ADDENDUM NO. 3

PROPOSAL FOR FURNISHING ALL LABOR, MATERIALS, EQUIPMENT, TRANSPORTATION, SUPERVISION, PERMITS, ETC. NECESSARY FOR THE MADISON HALL CHILLER REPLACEMENT, LOCATED AT THE UNIVERSITY OF LOUISIANA AT LAFAYETTE CAMPUS, LAFAYETTE, LOUISIANA.

Due July 9, 2025, at 10:00 AM Solicitation No.26203 (R1627530)

M1R1

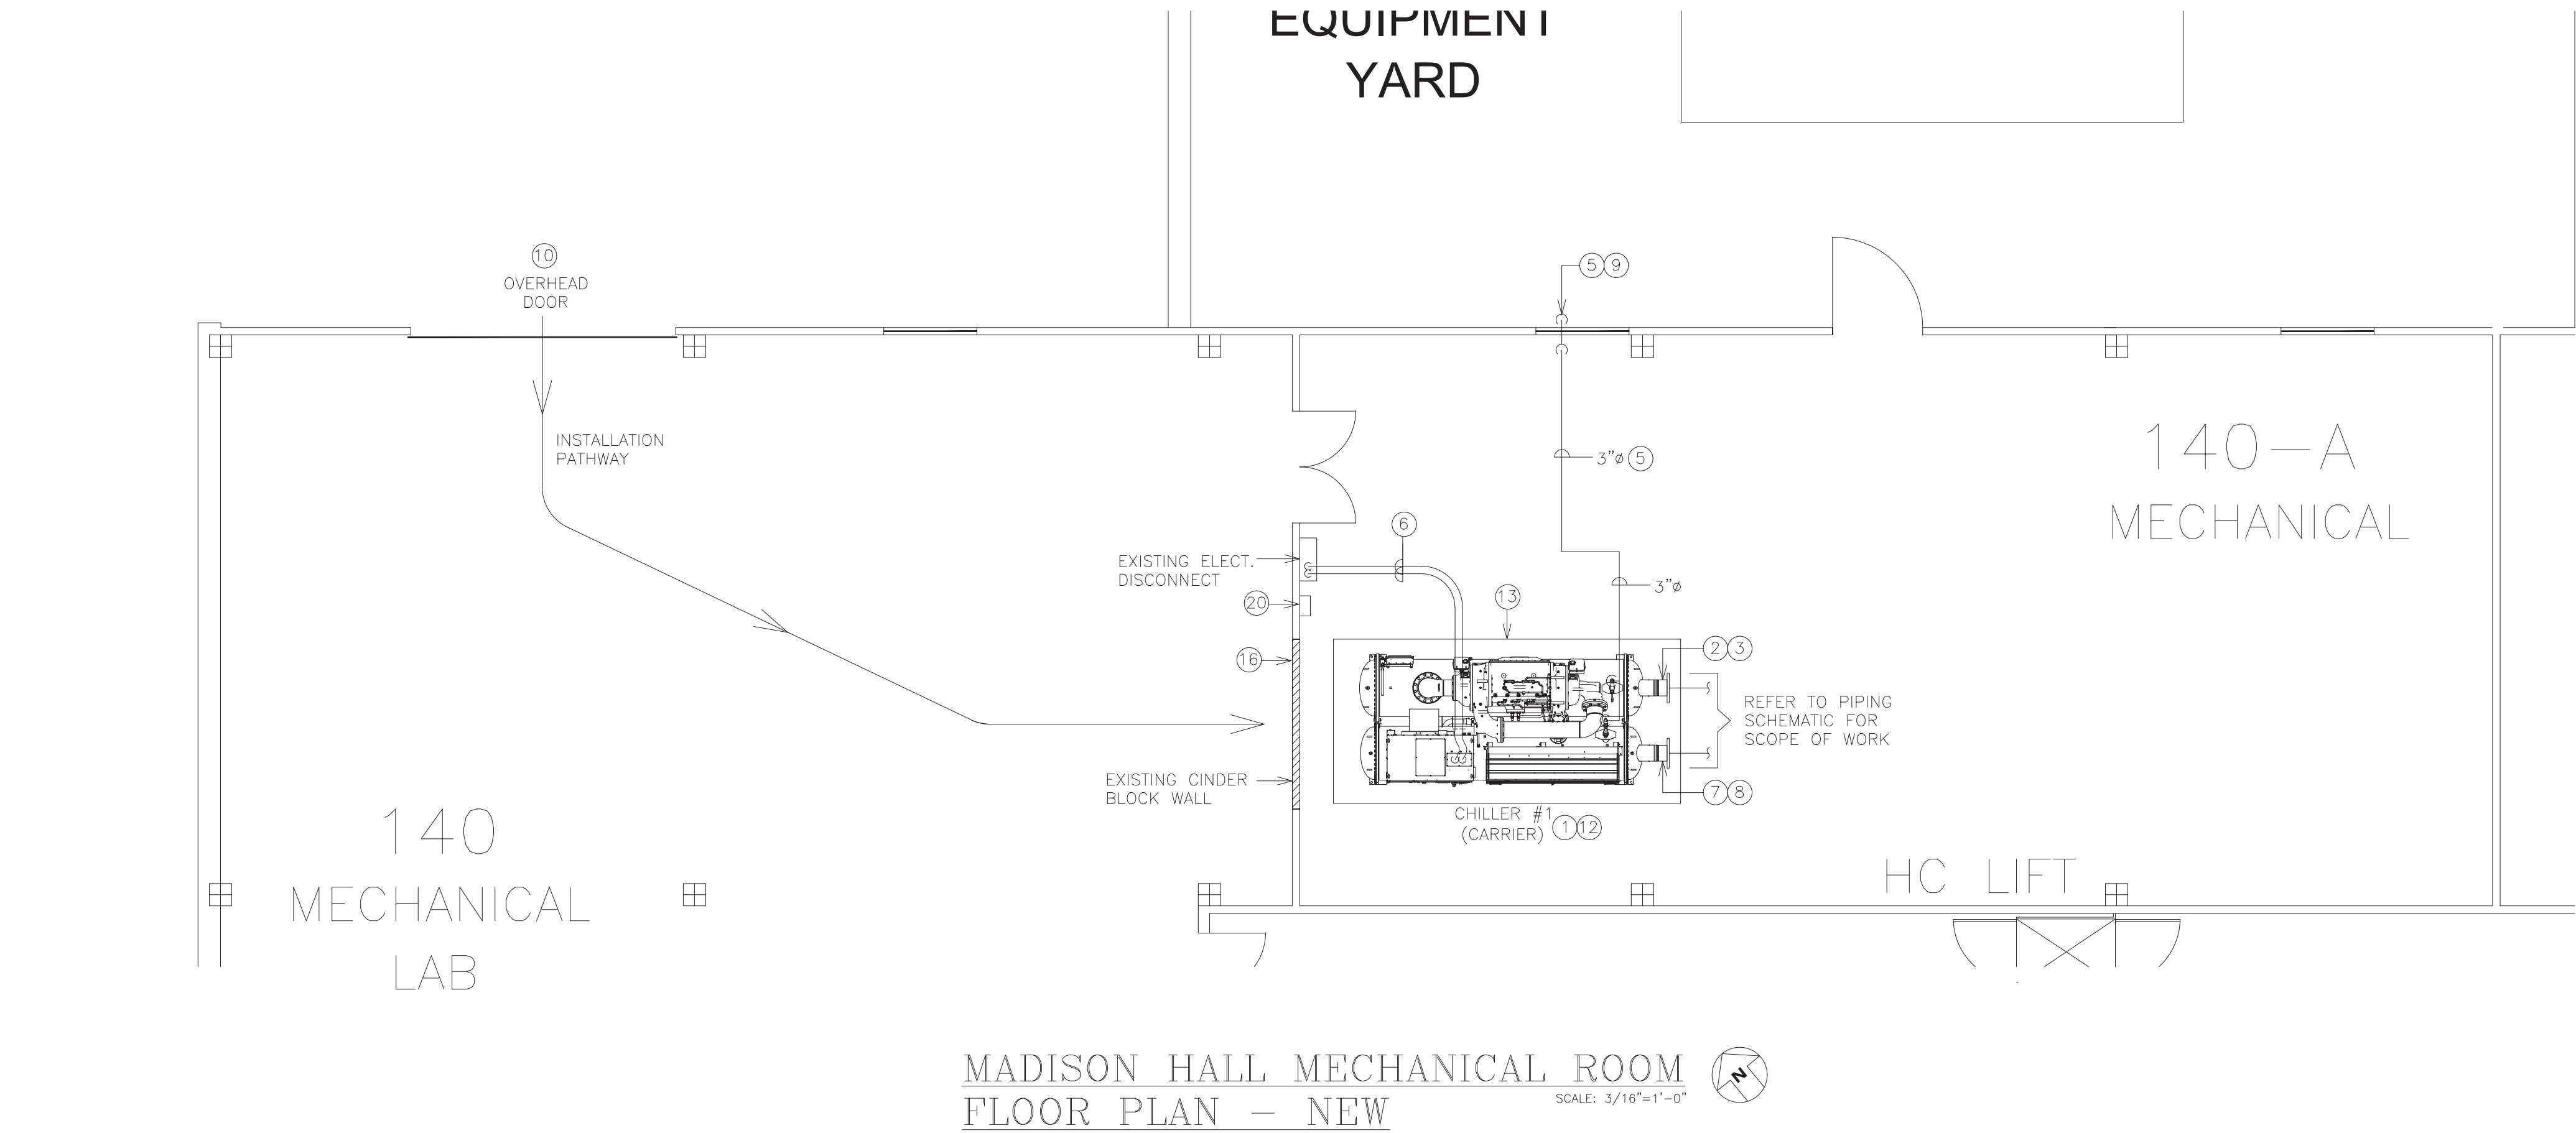
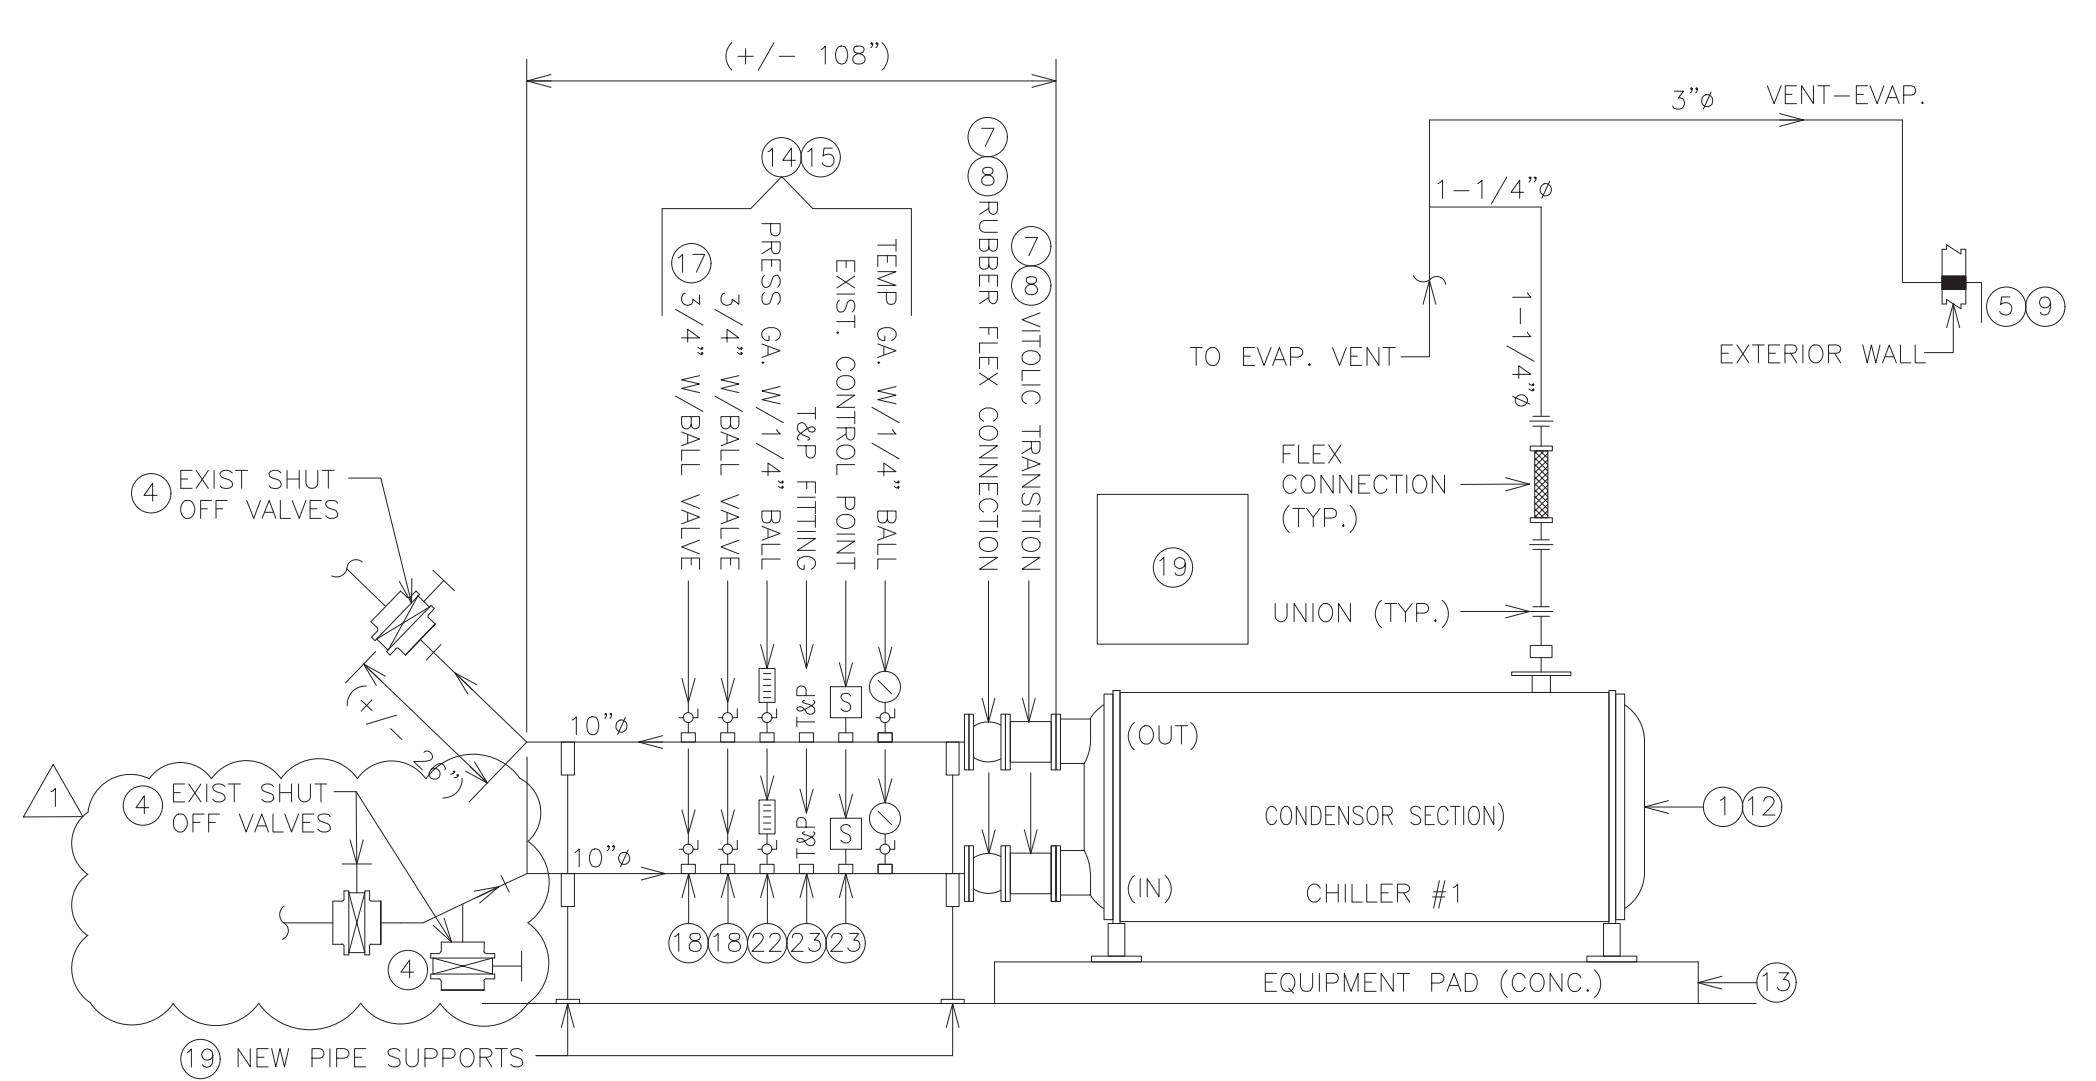
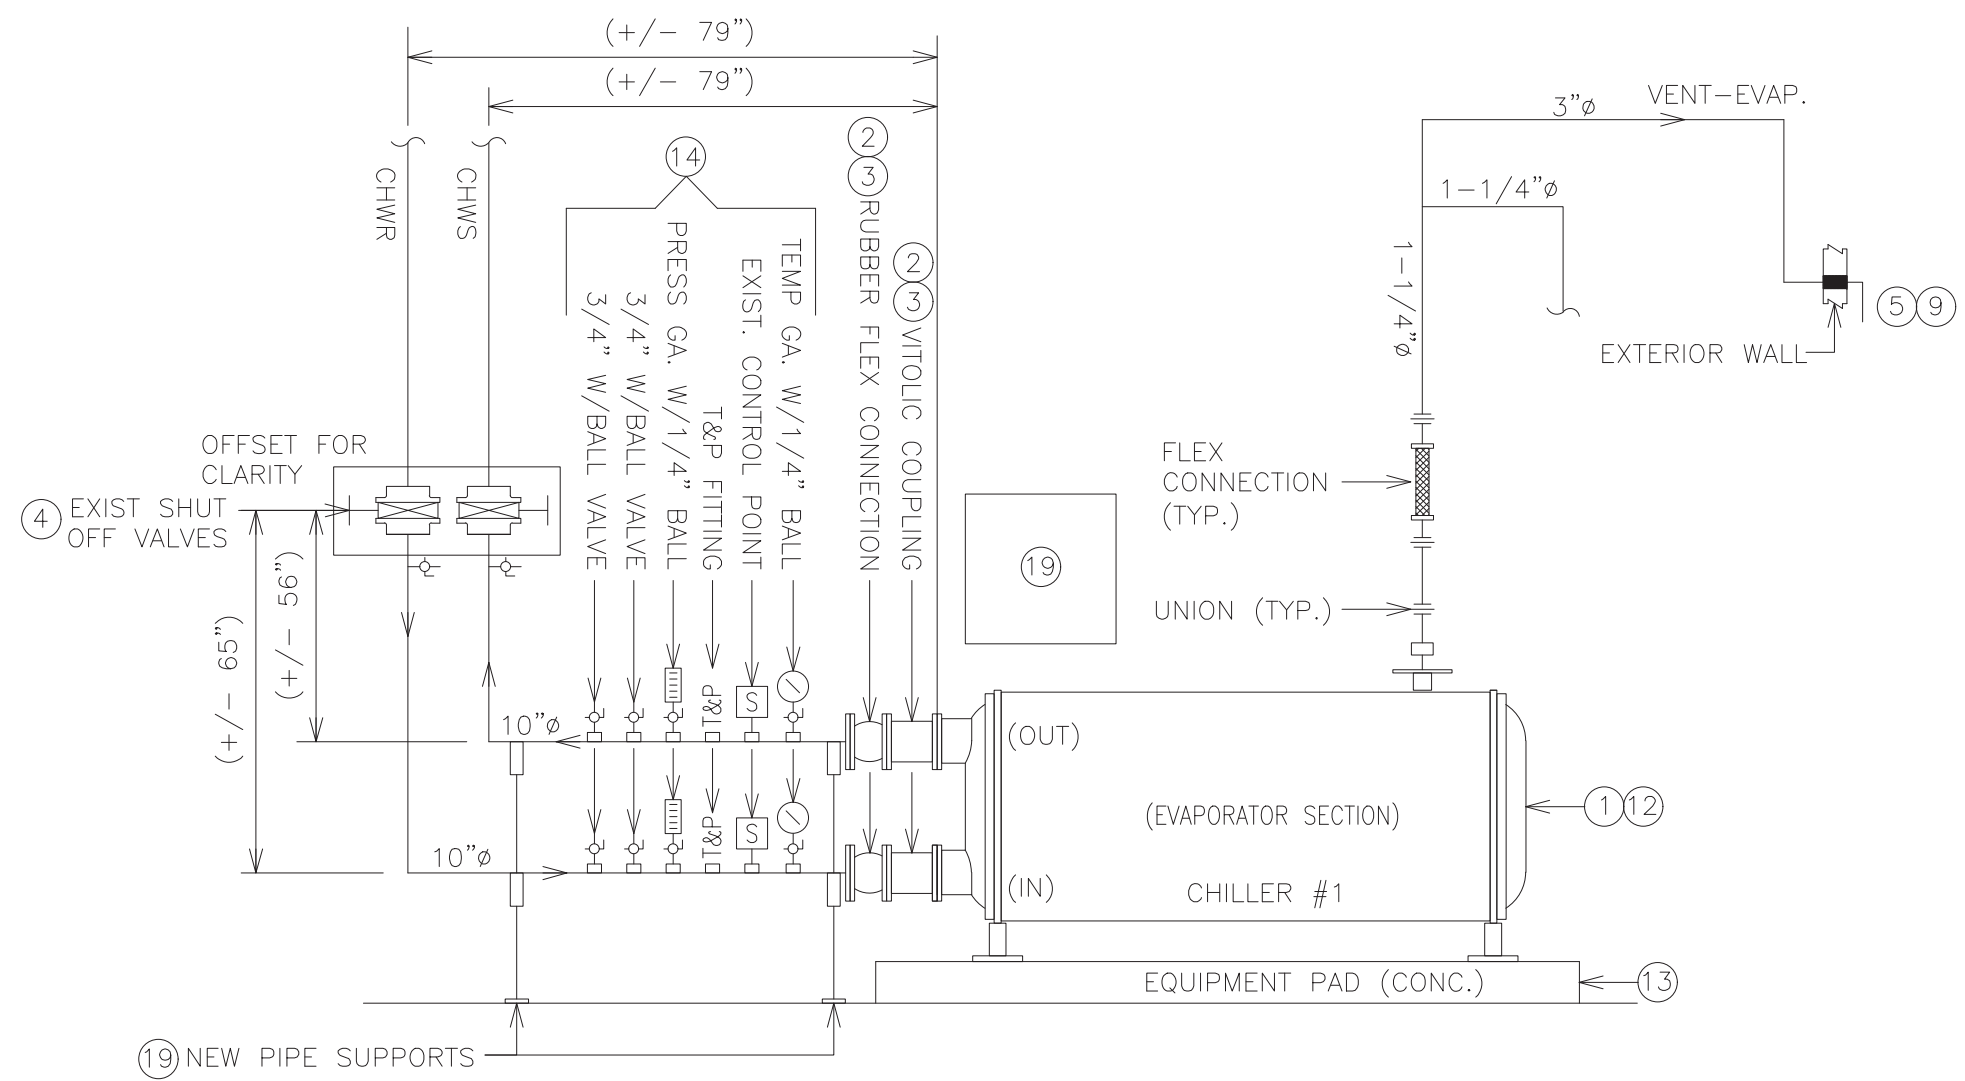
4. Reference Sheet M1. Replace current with revised sheet M1R1, dated 07/01/2025. Revisions include additions from previous addendums and the addition of Cooling Tower Scope. Cooling tower scope shall include cleaning of existing cooling tower and changing out motor and coupling. Refer to revised sheet.

COOLING TOWER SCOPE:

1. CONTRACTOR SHALL CLEAN EXISTING COOLING TOWER THOURGHLY. MARLEY COOLING TECHNOLOGIES (500T). SERIAL NO - NC8310F1GM. NC-245470-A1.
2. REPLACE EXISTING COOLING TOWER MOTOR AND COUPLING.
